**Re: Upper North Fork Feather River Hydroelectric Project, FERC Project No. 2105
Draft Environmental Impact Report, November 2014**

Pacific Gas and Electric Company (PG&E) appreciates the opportunity to provide comments on the State Water Resources Control Board's (State Water Board) draft Environmental Impact Report (DEIR) for the Upper North Fork Feather River Hydroelectric Project (UNFFR), November 2014, and Staff Recommendation dated November 26, 2014.

Figure 1: Monthly Comparison of Thermal Regime at Three Stations in the Belden Reach

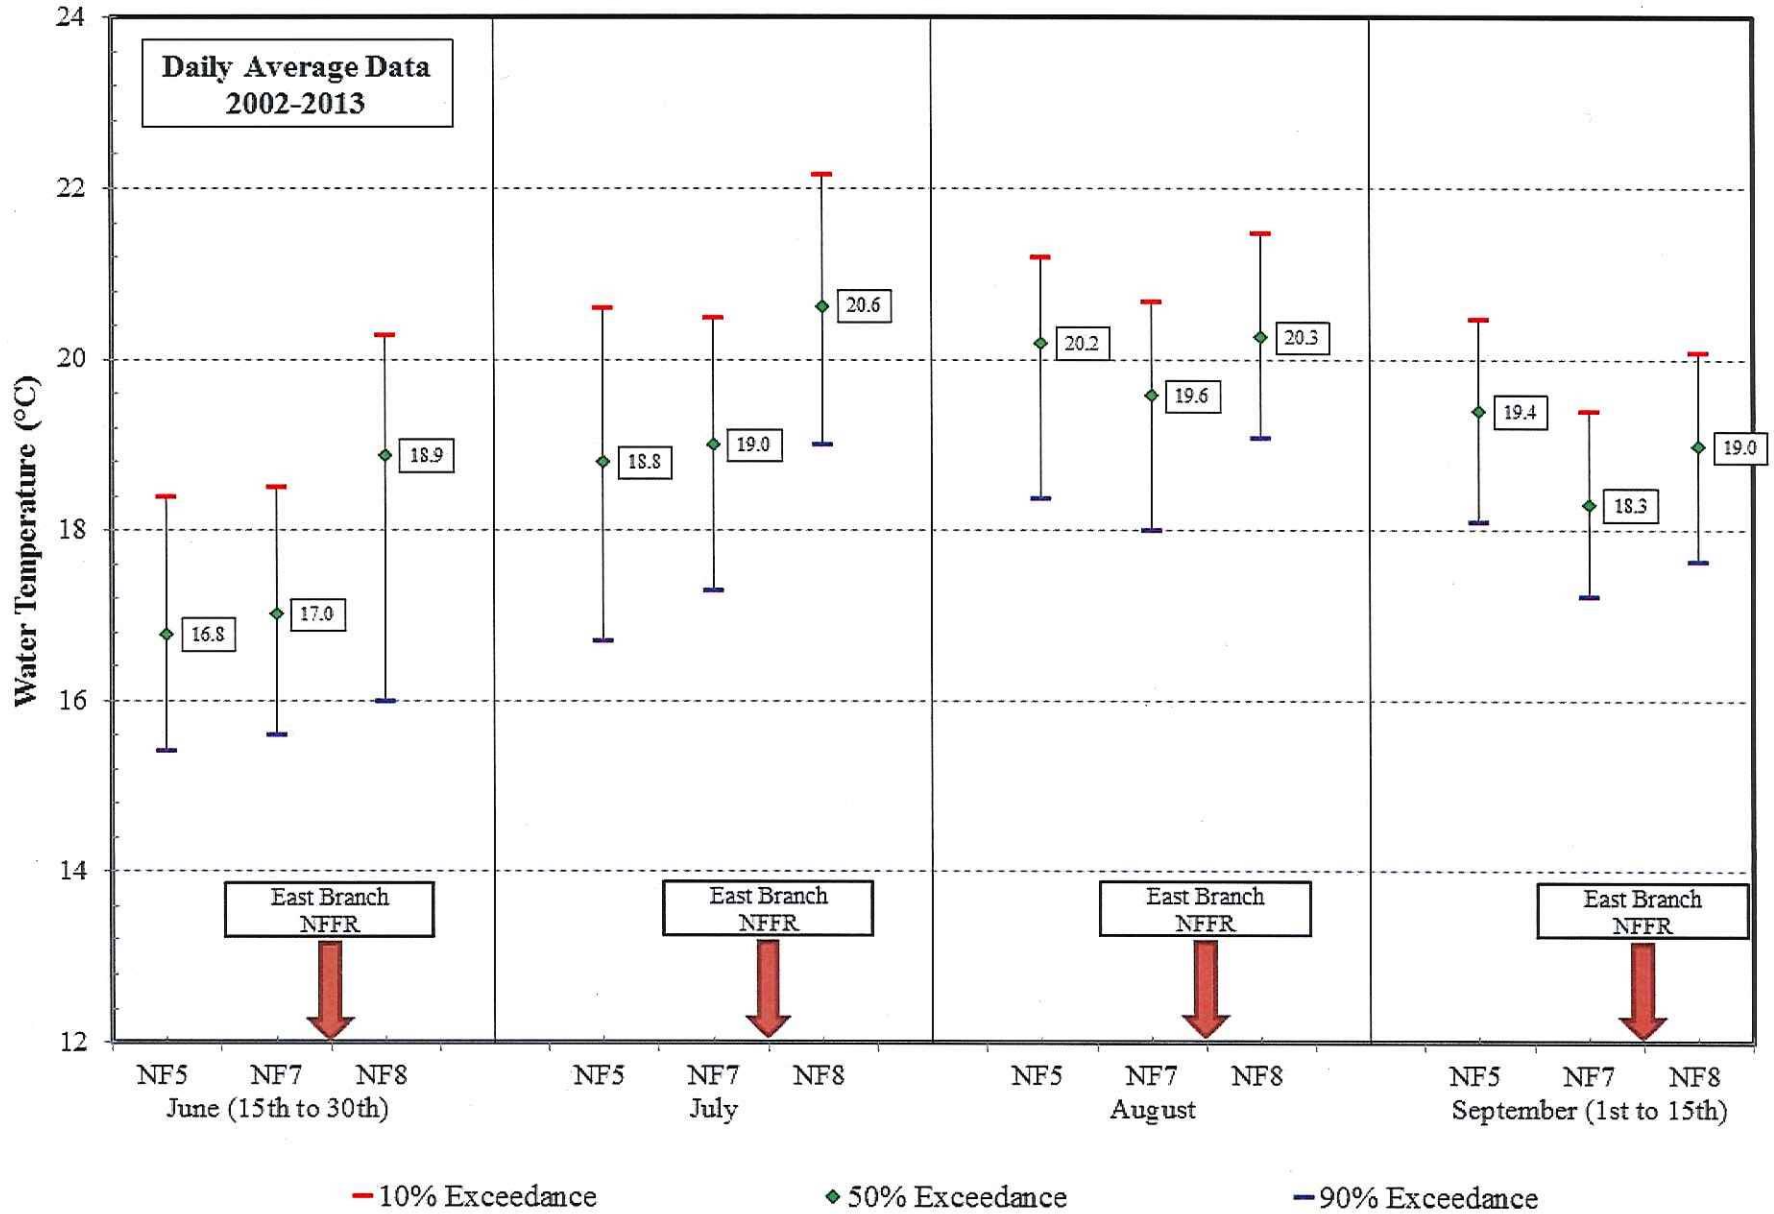
The current flows, which are lower than the Settlement Agreement flows in June and September, result in water temperatures in the UNFFR Project reaches below the 20° C criteria during these periods. Figure 1 shows summer water temperature monitoring results from 2002-2013 (including a range of all water year types) within the Belden Reach (NF5—below the Belden Dam; NF7—near Gansner Bar; NF8—at Belden Town Bridge below the confluence of the East Branch Feather River). Note that in the later part of June, and the first part of September, median temperatures never exceed 20° C. During these months, there is no water temperature related reason to increase flows beyond the Settlement Agreement flows in the UNFFR Project reaches.

For the Belden Reach, there is little to no information to support the statement above. With respect to water temperature, Figure 1 (above) shows the results of eleven years of water temperature monitoring in the Belden reach (2002-2013). The median heating in the reach from Belden Forebay to just above the East Branch NFFR is 0.2 ° C in June and July, and actually cools in August and September. At no time is the heating greater than the 5 ° F (2.7 ° C) objective stated in the Basin Plan. Even after the confluence with the East Branch (a typically warm, non-project affected branch of the NFFR) the water temperatures do not exceed the Basin Plan objective for the Belden reach.
